Illinois Department of Transportation
2300 South Dirksen Parkway / Springfield, Illinois / 62764

Subject: Revision #215

Date: August 20, 2013

Revision #215 of the Highway Standards, effective January 1, 2014, is now available on the Department's website.
The revisions are as follows:

STANDARD 701606–09

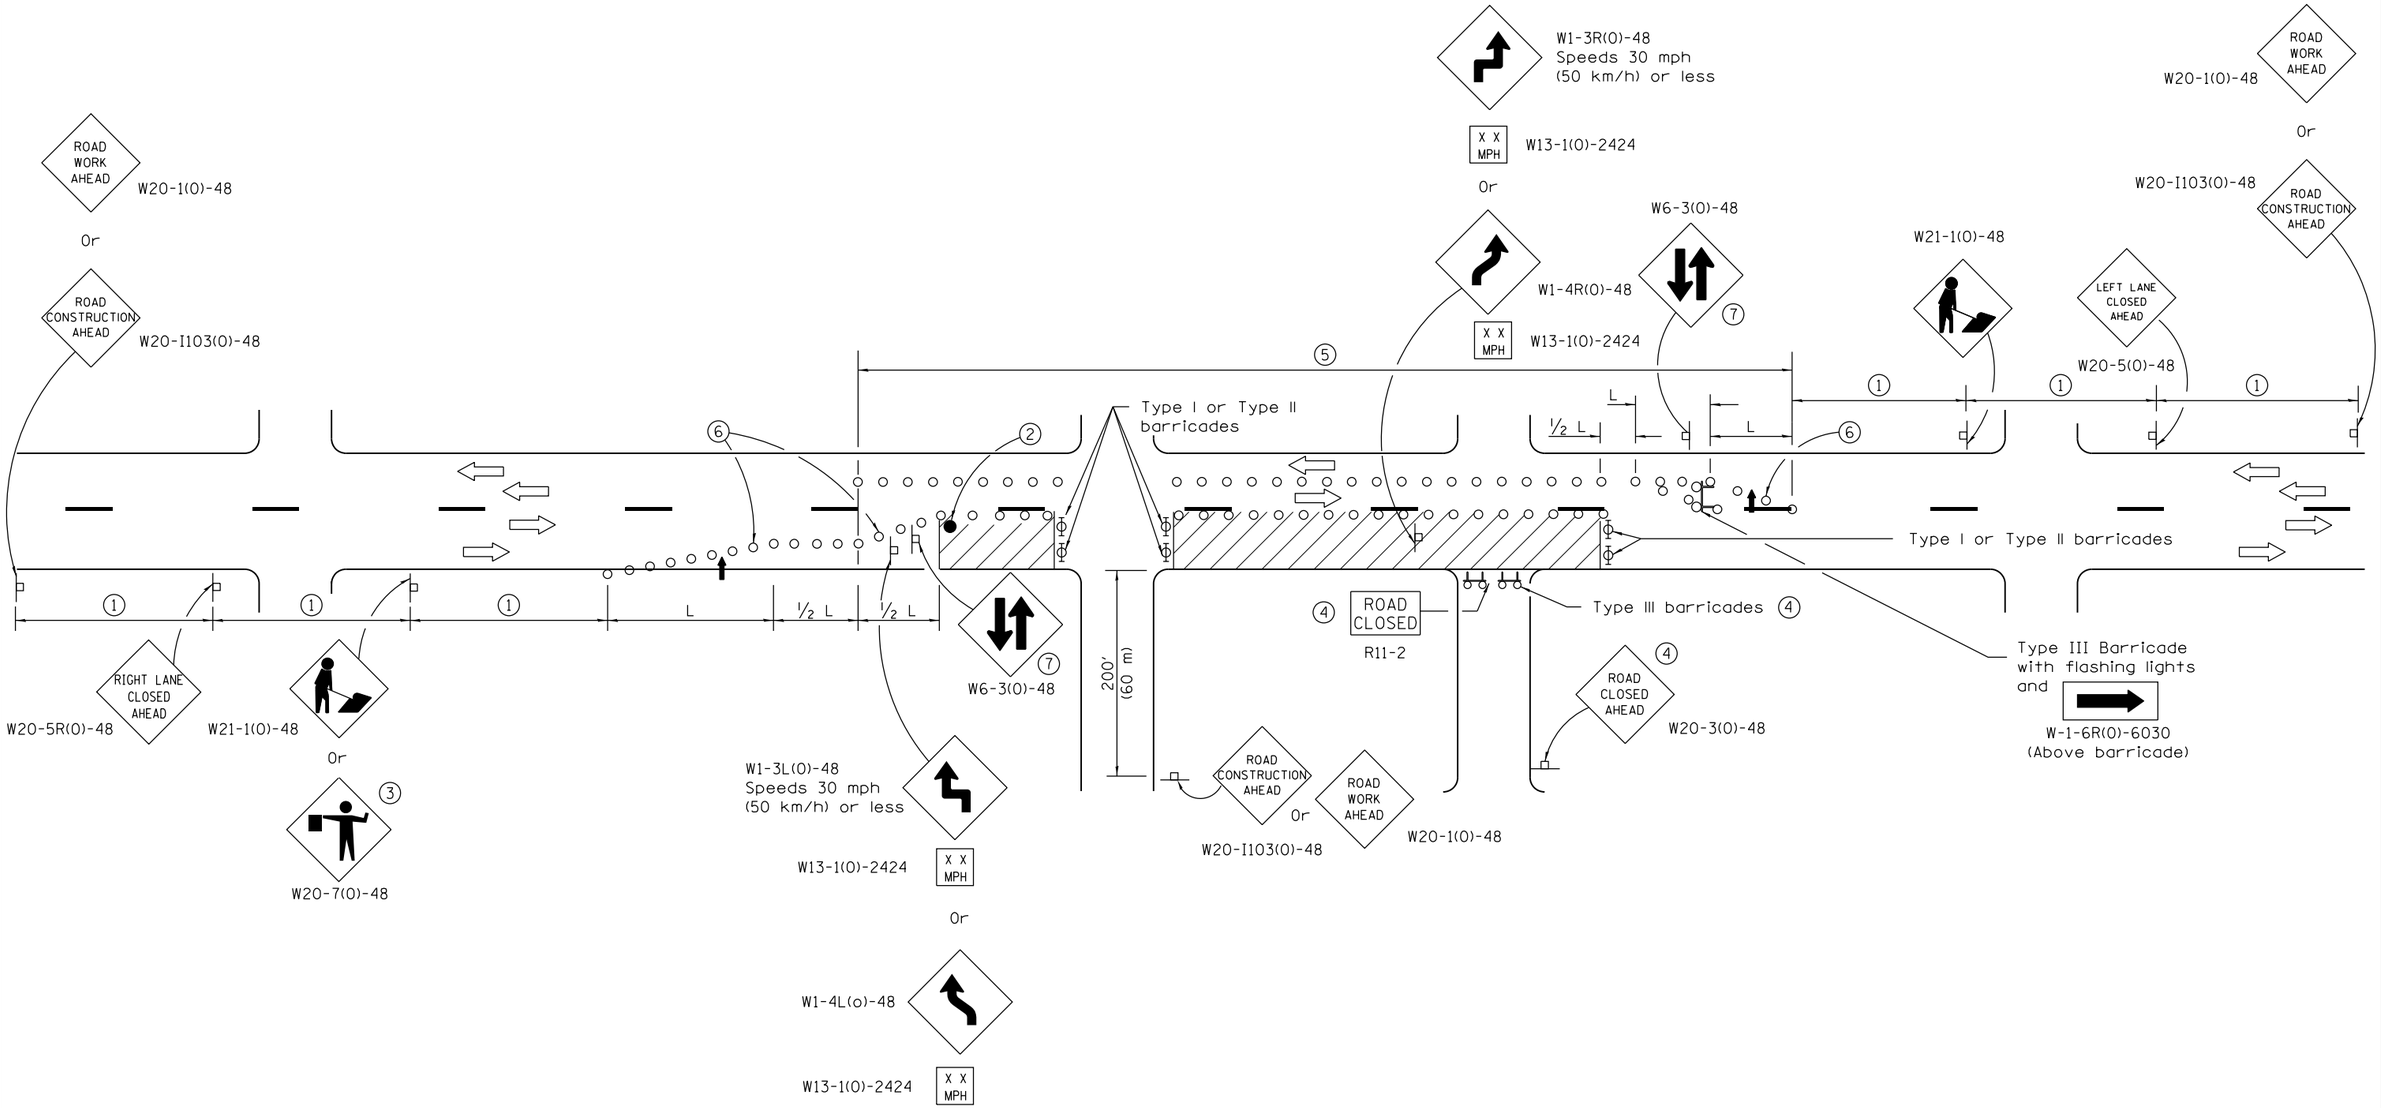
701602-06	701602-07	Revised worker sign number to agree with current MUTCD. Revised SIGN SPACING table.
701606-08	701606-09	Revised worker sign number to agree with current MUTCD.
701701-08	701701-09	Added devices at arrow board upstream from taper. Revised worker sign number to agree with current MUTCD.
701901-02	701901-03	Modified flagger sign height. Added construction zone speed zone signs.

STANDARD 838001

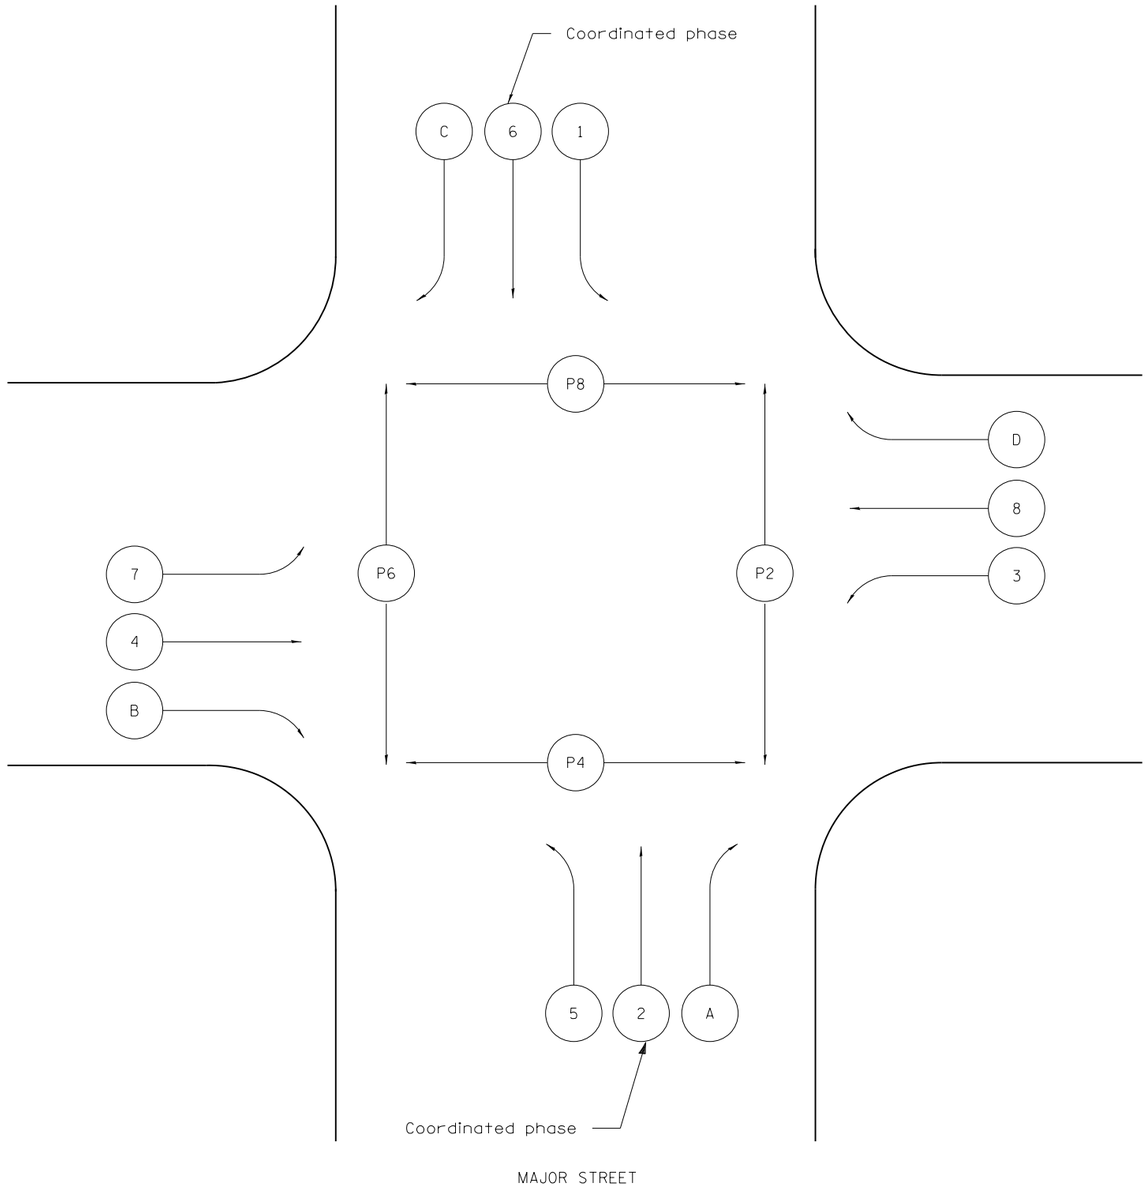
837001-02	837001-03	Revised diameter of grounding electrode sleeve.
	838001	New Standard.
876001-02	876001-03	Revised / added dimensions to add PROWAG requirements for reach ranges.
Division 000 Index January 1, 2013	Division 000 Index January 1, 2014	Updated.
